UNIVERSITY OF ILLINOIS
AT URBANA-CHAMPAIGN

October 26, 2004
Docket No. 50-151

Response to Request for Additional Information Dated Sept. 30, 2004
University of Illinois – Docket No. 50-151

CHART I: Administrative organization of the reactor facility. Dashed lines indicate reporting paths outside the operational chain of supervision, indicated by solid lines.

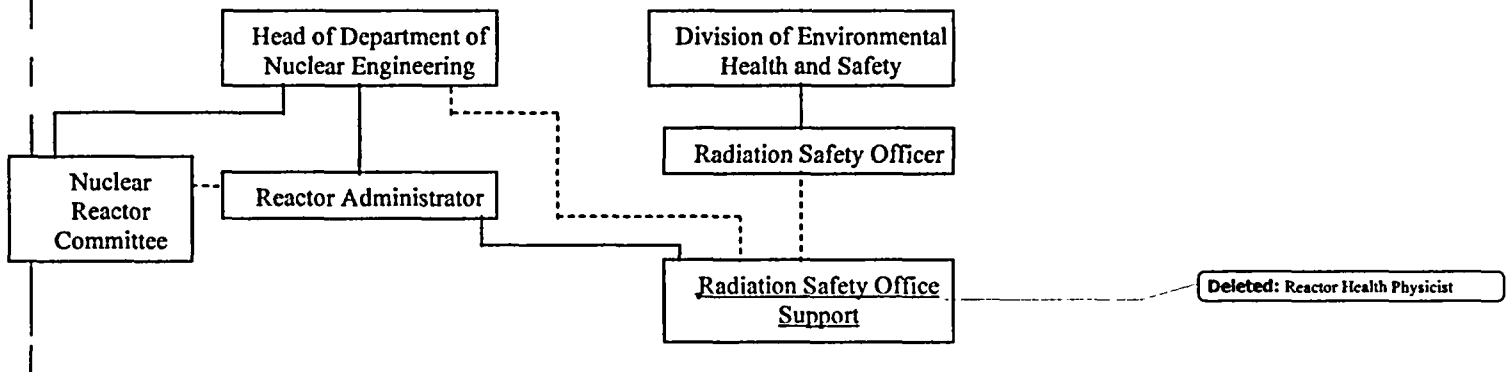
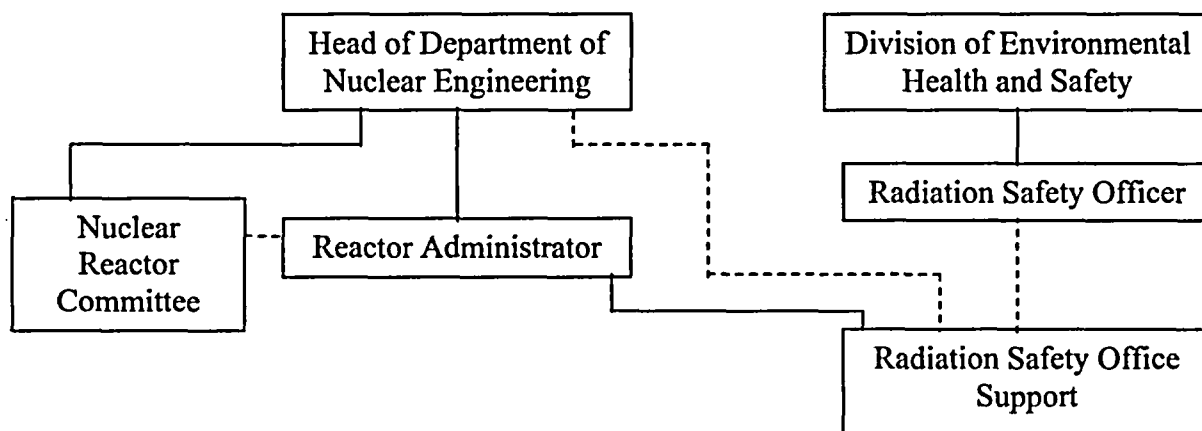
1. The existing technical specification (TS) 6.1.1 c. requires the Reactor Health Physicist to be responsible for assuring the day to day and routine radiological safety activities at the Nuclear Reactor Laboratory. Please describe how these activities have changed with the permanent shutdown and removal of reactor fuel from the facility such that the Reactor Administrator and Radiation Safety Office staff can perform the remaining duties. Your proposed changes to the TS 6.1.1 c. removes the entire first sentence which removes all responsibility for assuring the day to day and routine radiological safety activities. Please justify deletion of this entire sentence or replace the position of Reactor Health Physicist with Reactor Administrator and Radiation Safety Office staff to reflect the transfer of responsibility as discussed in your justification.

Section 6.1.1.c has been revised to reflect that the responsibilities for day to day radiological safety activities belong to the Reactor Administrator with the support of the Radiation Safety Office. With the removal of the fuel from the facility the radiological support for the facility is reduced. The facility has no activities in it from researchers, etc. The building is effectively mothballed pending development and approval of a decommissioning plan. Current needs for radiological controls at the facility are commensurate with mothballing. At such time that decommissioning activities are in progress, other support for radiological safety will be required and appropriated. A revised copy of the Technical Specifications is attached.
